UNITED STATES PATENT AND TRADEMARK OFFICE

APPLICATION NO.	FILING DATE	FIRST NAMED INVENTOR	ATTORNEY DOCKET NO.	CONFIRMATION NO.
10/766,508	01/28/2004	J. Lamar Banks	8B12.1-011	3505

Office Action Summary

DETAILED ACTION

J. O. ATKINSON.
FOLDING FEED TROUGH OR RACK.

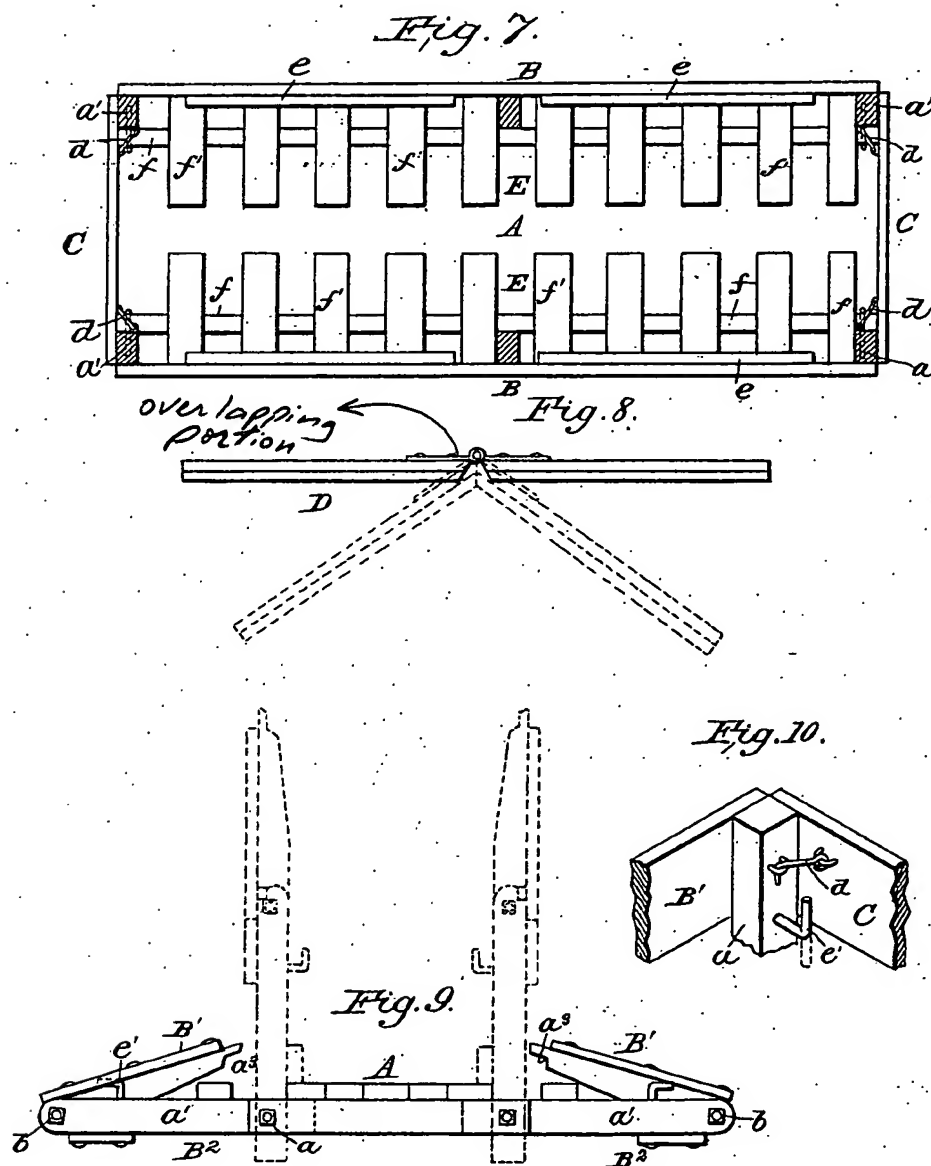
For claim 11, McCollough as modified by Atkinson (emphasis on Atkinson) further discloses one of the panels has a portion overlapping the other panel (see Figure 8 as labeled in the attached Figure 8 with the Office Action).

W. A. McCOLLOUGH.
BACK FOR FEEDING TROUGHS.
APPLICATION FILED OCT. 10, 1908.

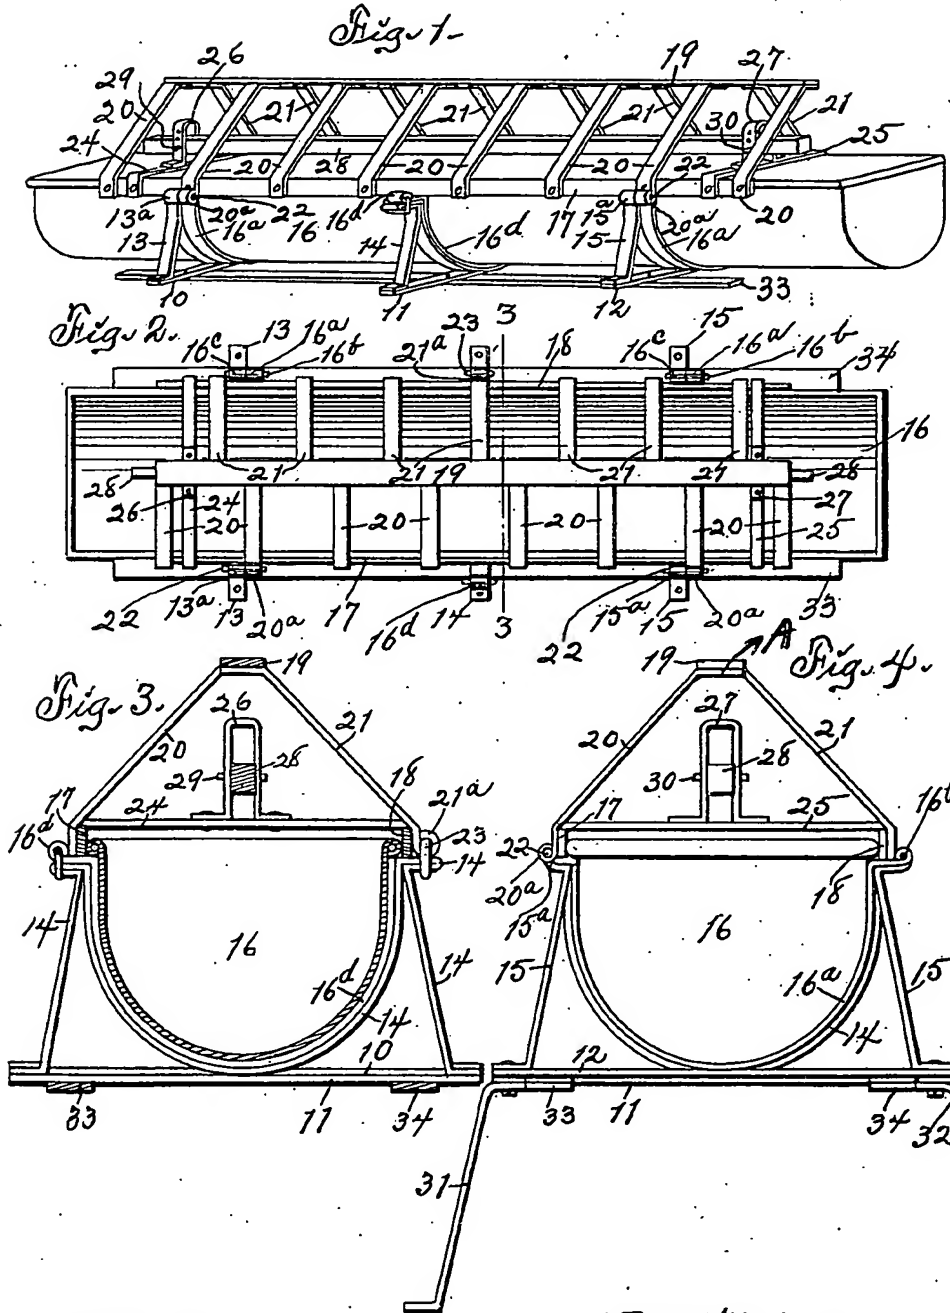
For claim 8, McCollough as modified by Atkinson (emphasis on McCollough), further discloses roof supports each comprise at least one central segment (19), at least three top end segments (20, 21, A in Figure 4 as labeled in the attached Figure 4 with the Office Action) angled with respect to each other, and at least two bottom end segments (17, 25) angled with respect to each other, wherein at least one of the top end segments is detachably coupled to the central segment.
